PRODUCTION DWG

TOLERANCES (EXCEPT AS NOTED)		SHINTRON COMPANY INC	
DECIMAL ±	MODEL 351	SCALE —	DRAWN BY ADB APPROVED BY T-30-71 <i>AT</i>
FRACTIONAL ±	TITLE SCHEMATIC		
ANGULAR ±	DATE 2/8/71	DRAWING NUMBER 30C0625 H

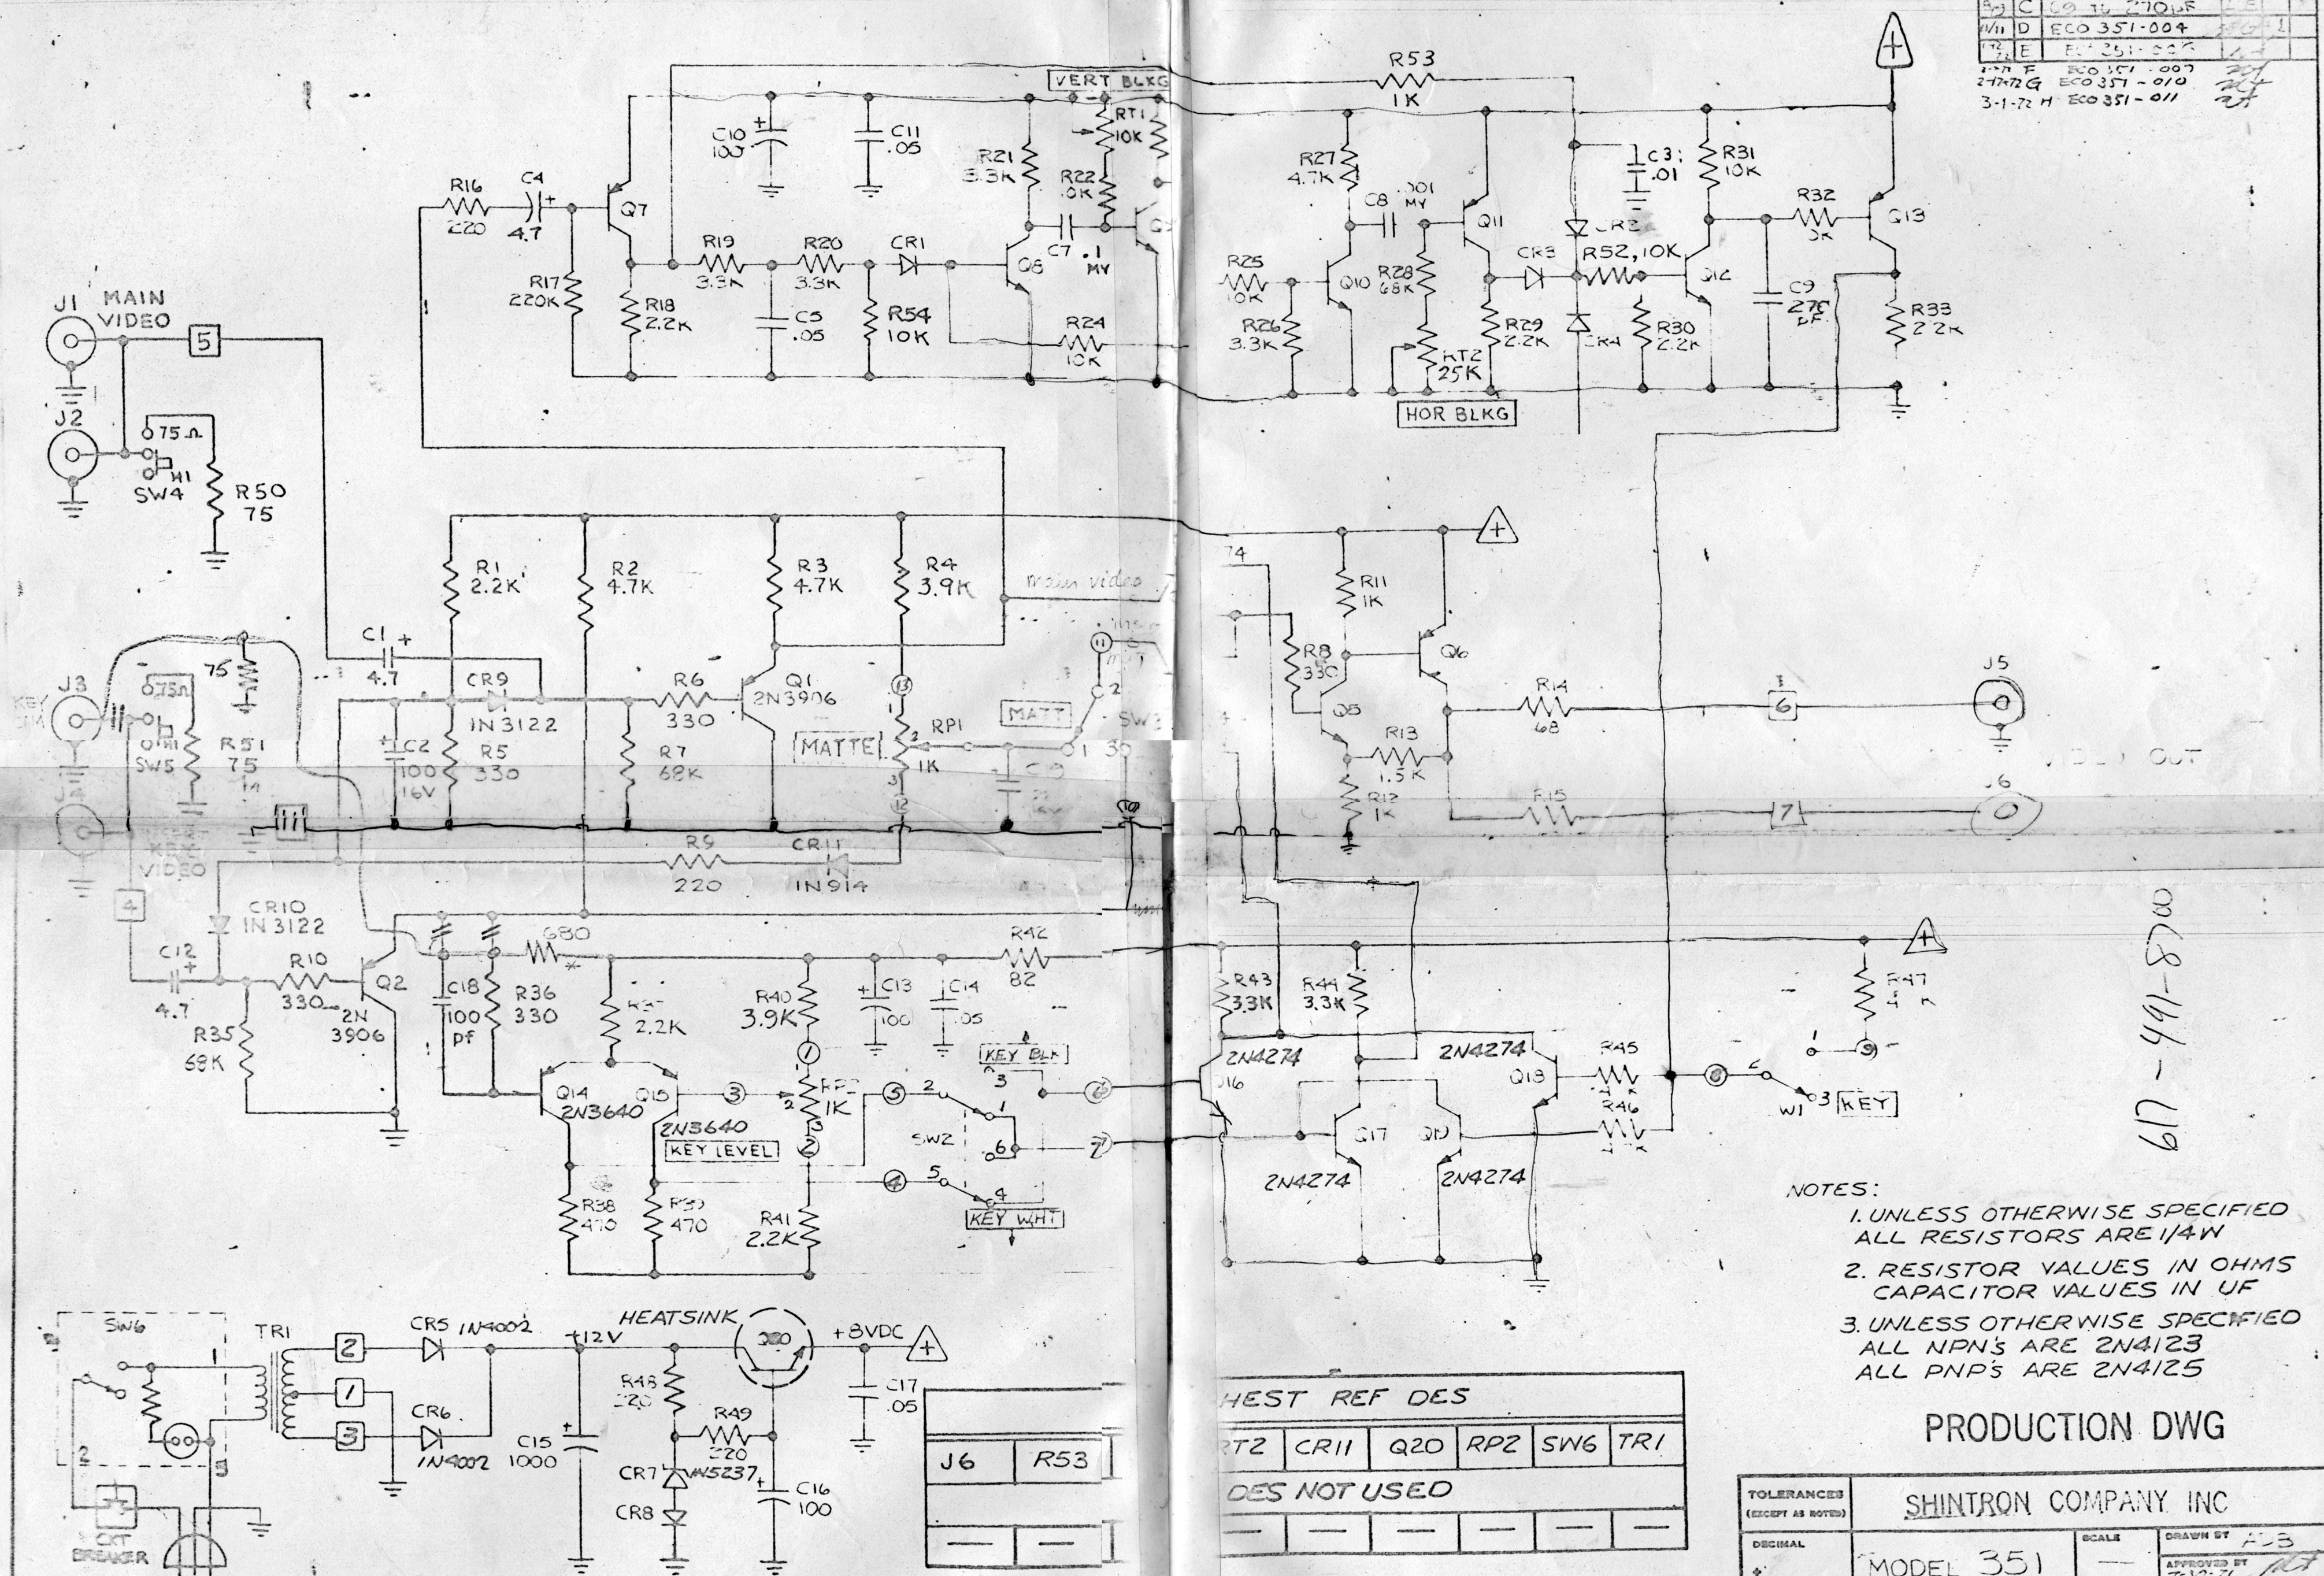
MODIFICATIONS FOR 2 VIDEO, 1 KEYING INPUT  
 # = CUT WIRE (3); 2 RESISTORS ADDED.  
 680Ω \* MAY NEED TO BE ADJUSTED TO GET FULL KEYING
